# **Safety Evaluation Report (Revised)** for the Dewey-Burdock Project Fall River and Custer Counties, South Dakota

## **Materials License No. SUA-1600**

Docket No. 40-9075  
Powertech (USA) Inc.

**April 2014**

Figure 1. Comparison of the Reported Drawdown and Drawdown from the modeling Software

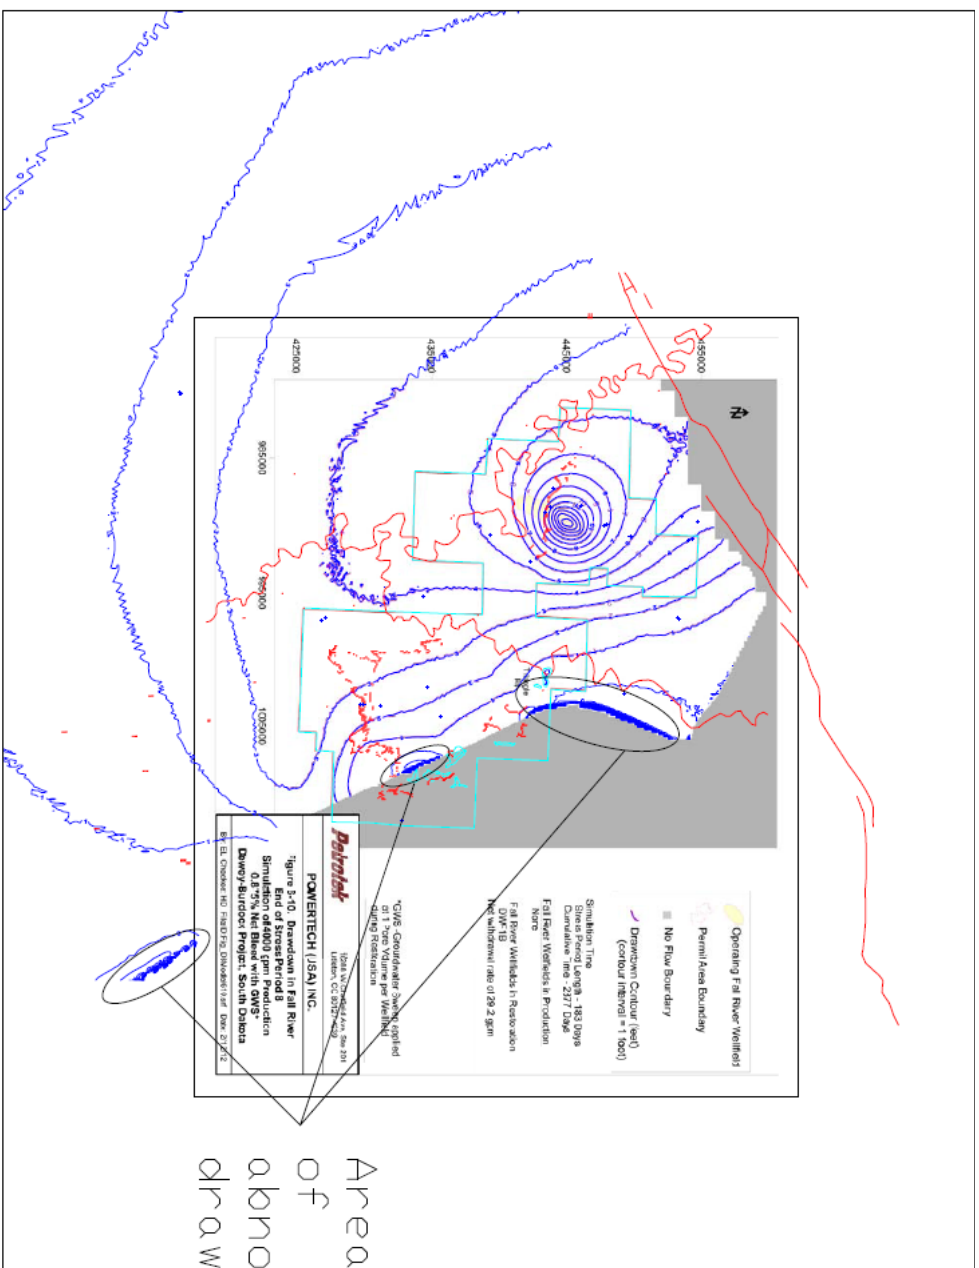
Staff reviewed the model geometry, hydraulic properties and parameters and locations of the boundaries. Several minor discrepancies were noted between the electronic files and the report (Table 1). In general, the discrepancies represent minor errors and are common for complex models. Most of the discrepancies would not appreciably impact the model predictions; however, staff was concerned about the abnormal drawdown adjacent to the GHB conditions (Figure 1). The abnormal drawdown may be attributed to discrepancies noted in the recharge, storativity or GHBs (see Table 1), or, conflicts with the starting head file.<sup>1</sup>

Staff corrected the model for discrepancies in recharge, storativity and GHBs, and established starting heads for the predictive simulation using the output from the steady-state calibration simulation. Correcting the model affected the predicted drawdowns in the Fall River Formation and Chilson Member, as shown in Figure 2 and Figure 3, respectively. The effect of the corrected model on the Fall River Formation model-predicted drawdown is to increase the drawdown by approximately 1 foot. The effect on the Chilson Member model-predicted drawdown is less than that for the Fall River Formation.
